Stairway Shaft Enclosures & Framing

Intermediate Landing
Beam Extends into Shaft
Wall – Oversize to Provide
2 Hour Fire Protection
Using Calculated Char
Rates

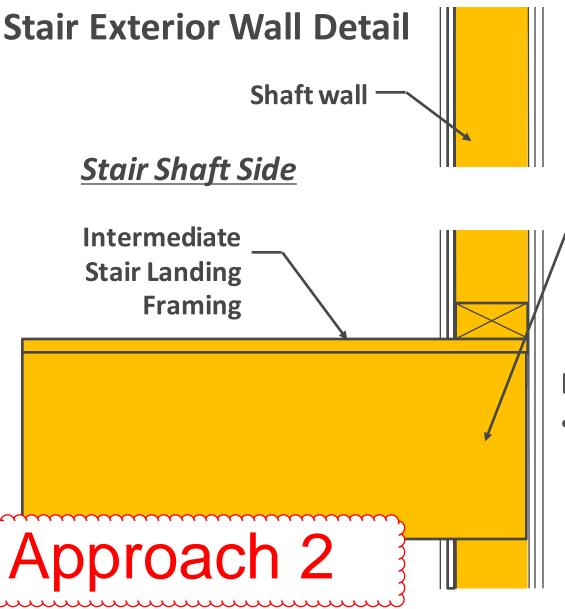
Rationale for detail approval:

Membranes on both side of wall provide fire resistance via their approved assembly; at floor cavity beam oversized to provide 2 hour char protection
